20125-01-001 – Rev A

**Quins Cross to Raheen Roundabout
Cycle Scheme, Limerick**

ROAD SAFETY AUDIT STAGE 1

November 2021

2.1 Problem

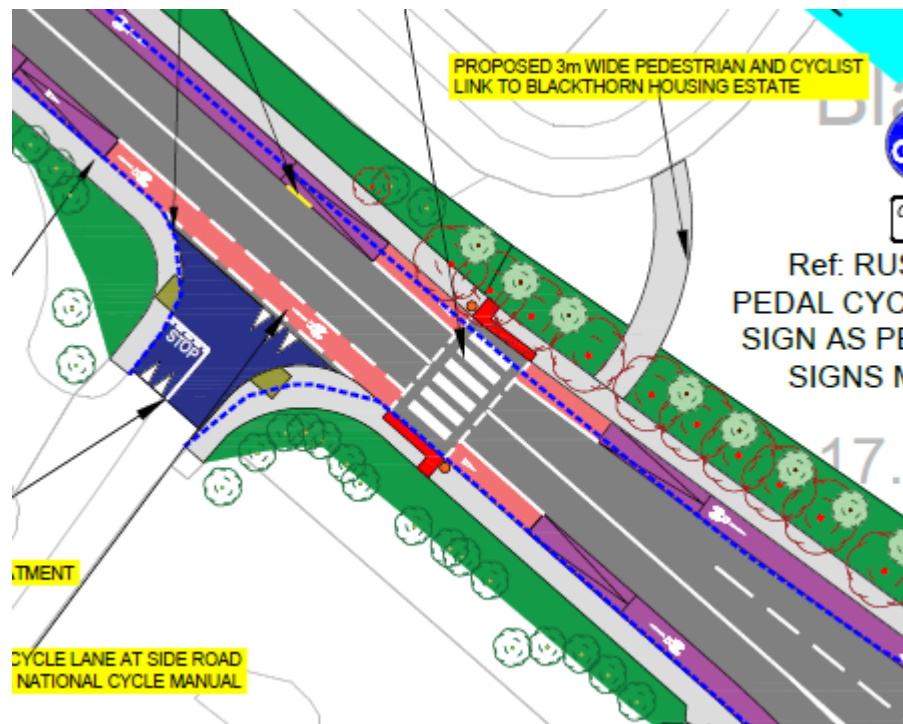
It is unclear how it is intended that cyclists on the existing carriageway, exiting the Raheen Roundabout onto the R510 Raheen Road, can safely access the start of the proposed off road cyclepath. A lack of an adequate safe access point may result in cyclists remaining on the narrowed carriageway where they would be at an increased risk of being struck by a passing vehicle.

Provide an adequate access point at the commencement of the off road cyclepath to allow cyclists exiting the roundabout to safely access the cycle facility. When considering the layout of the access point, the designer should take cognise of the existing pedestrian crossing at Raheen Roundabout to avoid any conflict with pedestrians crossing at this location.

2.1	Y	Y	-----	-----
2.2	Y	Y	It is now being proposed to raise the zebra crossing and cycle facility above the road level leaving safe access for cyclists.	-----

2.3 Problem

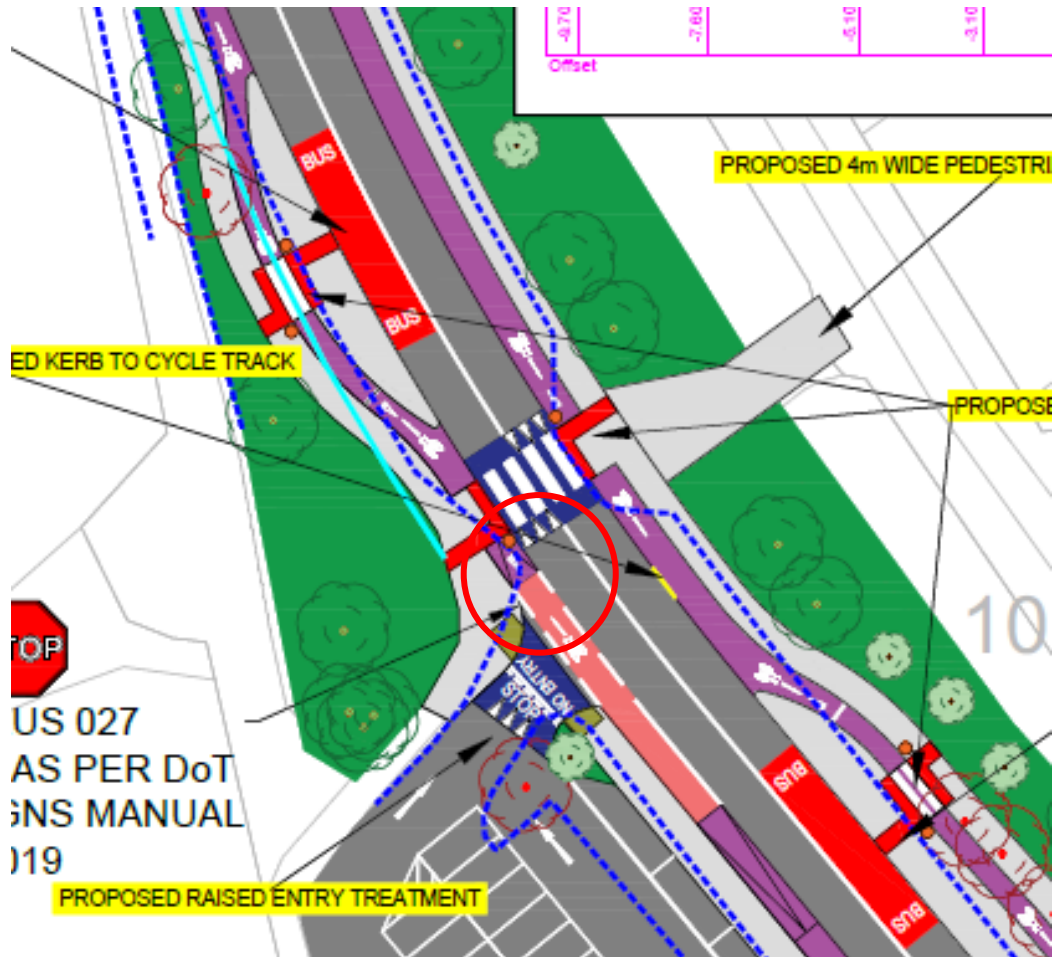
Visibility at the proposed exit from the existing parking area at the front of St. Nessian's National school may be restricted by vegetation and parked vehicles in the school car park to the southeast and buses stopped at the on-road bus stop to the northwest. A lack of adequate visibility may contribute to turning conflicts at the proposed exit.

Ensure that adequate visibility splays are provided at the proposed exit from the existing parking area at the front of St. Nessian's National school.

2.3	N	N	Adequate visibility is being provided	Yes
2.4	Y	Y	Adequate visibility is being provided for a 30kph Design Speed if buses are present, 50kph Design Speed visibility available if no buses are parked at the bus stops.	-----

2.4 Problem

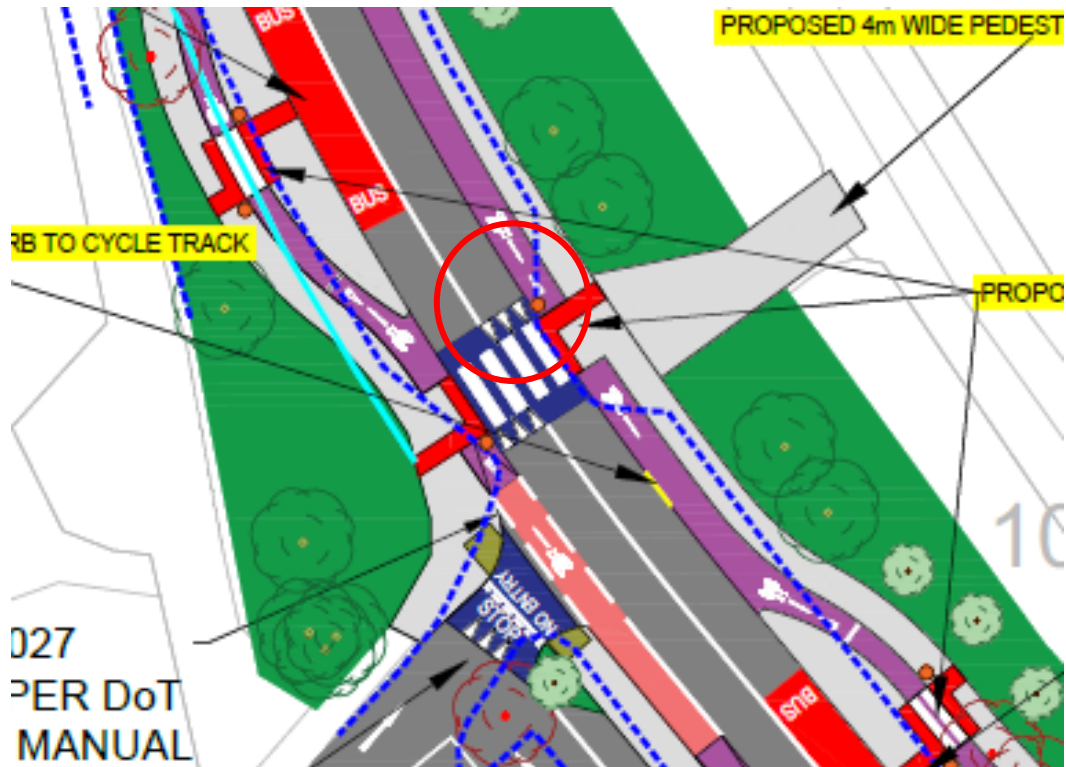
Inter-visibility between pedestrians crossing at the proposed pedestrian crossing and drivers of vehicles approaching the crossing may be restricted by buses stopped on the on-road bus stops on either side of the pedestrian crossing. A lack of adequate visibility splays may contribute to a pedestrian collision at this location.

Ensure that adequate inter-visibility splays are provided between pedestrians crossing at the proposed pedestrian crossing and drivers of vehicles approaching the crossing.

2.5 Problem

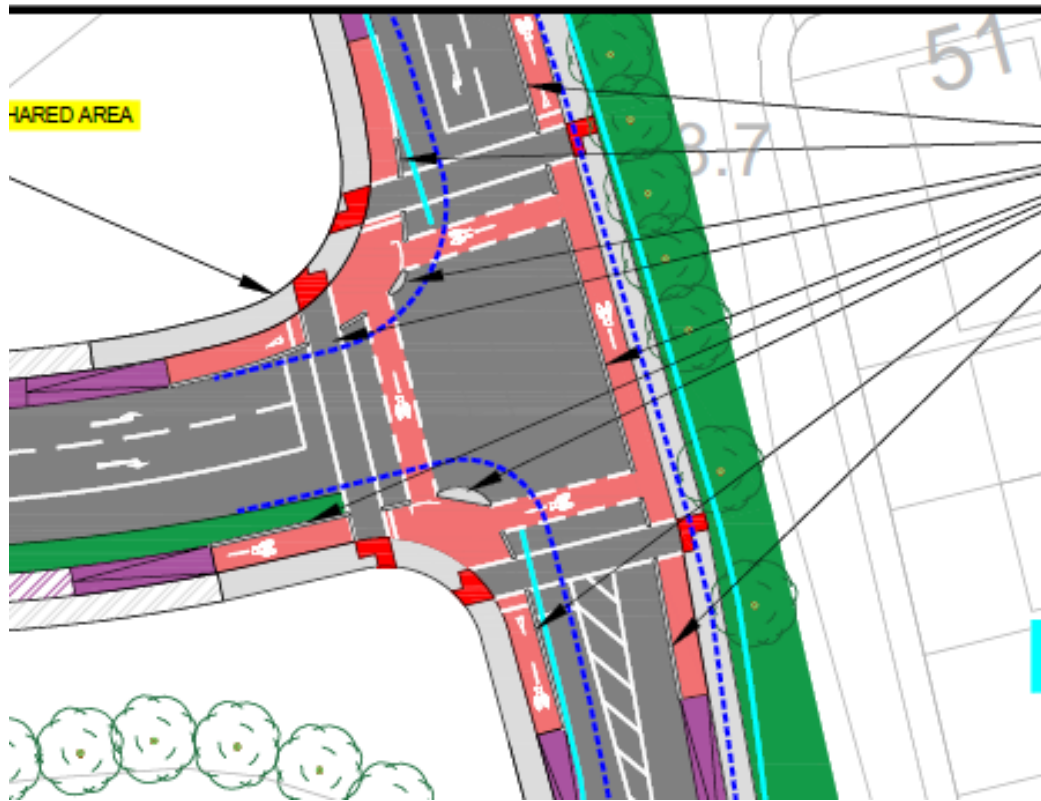
A continuous white centreline is proposed along the scheme extents. Such a road marking prohibits overtaking along sections where overtaking a slow moving or stationary vehicle is feasible. This may lead to driver frustration and carrying out dangerous overtaking manoeuvres elsewhere.

Provide a broken line marking where appropriate.

2.5	Y	Y	-----	-----
2.6	Y	Y	DETAILED DESIGN STAGE	-----
2.7	Y	Y	DETAILED DESIGN STAGE	-----
2.8	Y	Y	DETAILED DESIGN STAGE	-----
2.9	Y	Y	DETAILED DESIGN STAGE	-----

2.8 Problem

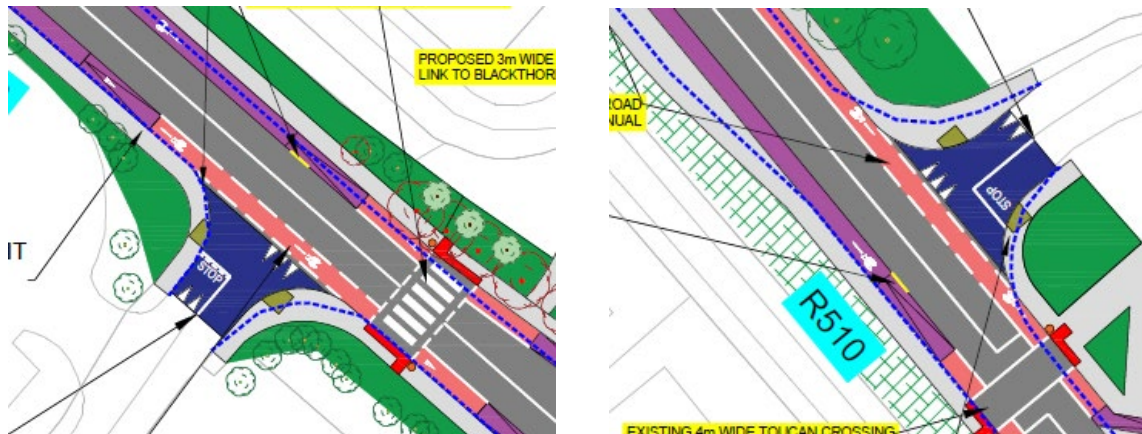
Drop kerbs have been shown opposite priority junctions throughout the scheme. However, the dropped kerbs appear short. This results in a tight angle that cyclists have to navigate to exit the carriageway quickly. This may contribute to cyclist injury due to loss of control or if struck by a vehicle when attempting to access the cycle facility.

Provide adequate cycle facilities at all priority T-junctions to allow cyclists to turn right.

2.10 Problem

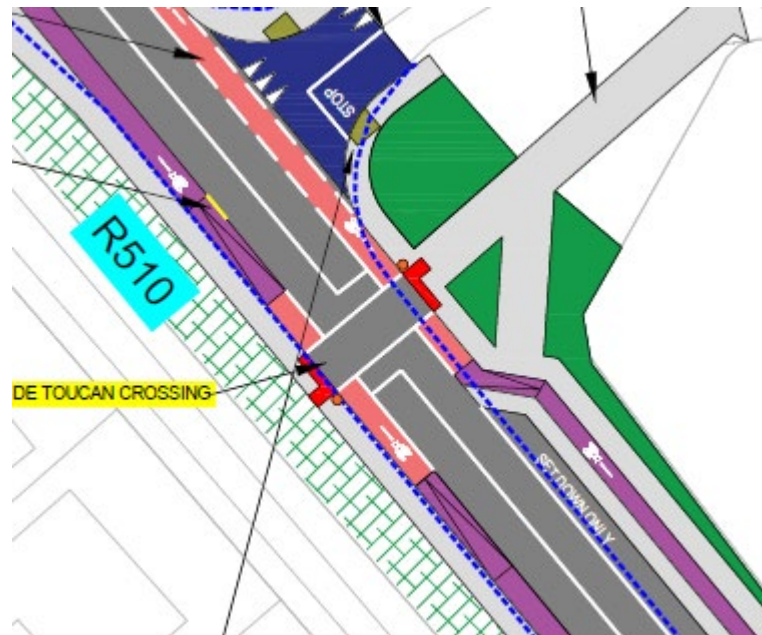
Belisha beacons as shown to be provided at the proposed toucan crossing adjacent to the junction with Church Road. The proposed belisha beacons are inconsistent with the proposed toucan crossing which could cause confusion and lead to collisions at this location.

Replace the belisha beacons with pedestrian signals at this location.

2.10	Y	Y	-----	-----
2.11	Y	Y	-----	-----
2.12	Y	Y	-----	-----

2.11 Problem

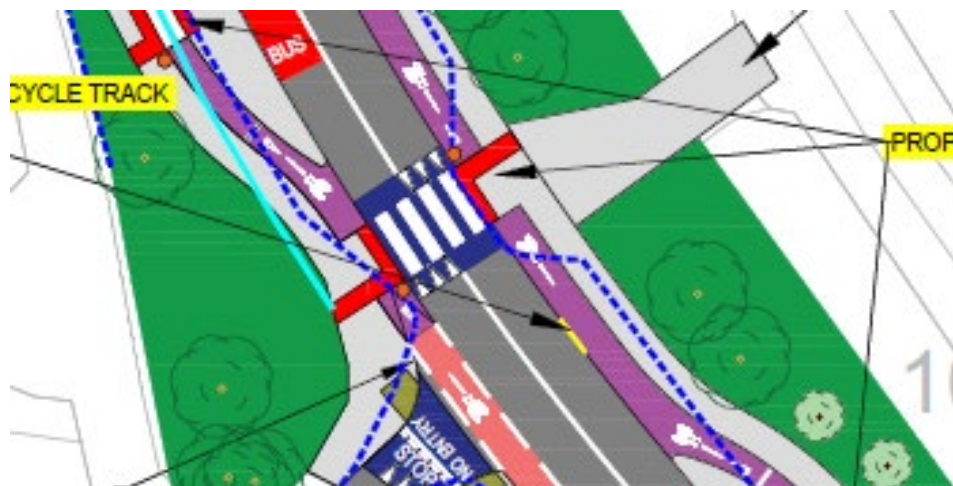
The cycle facility is shown to ramp up to footpath level at its intersection with the pedestrian crossing immediately north of St Nessans school on both sides of the road however corduroy hazard warning tactile has not been provided to warn users of the crossover between cyclists and pedestrians at these locations. This could increase the risk of cyclist / pedestrian collisions.

Adequate tactile paving should be provided to ensure all users are aware of the crossover between pedestrians and cyclists.

2.12 Problem

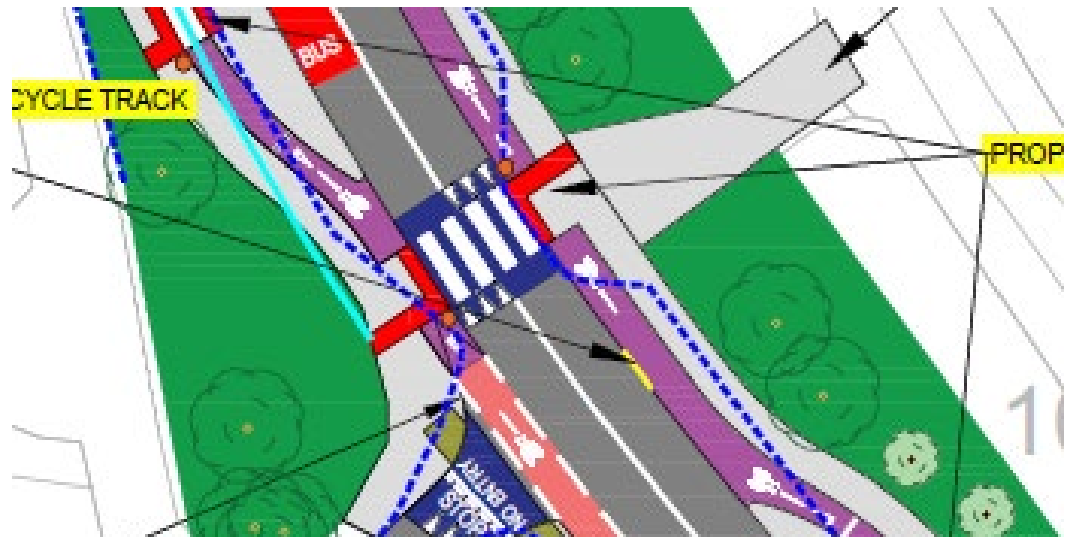
Proposed Belisha Beacons are located within the proposed cycle facility at its intersection with the pedestrian crossing immediately north of St Nessans school on both sides of the road. This may reduce the available width for cyclists which could increase the risk of cyclist collisions.

Belisha Beacons should be positioned to avoid any conflict with pedestrians or cyclists on the proposed cyclepaths and footpaths.
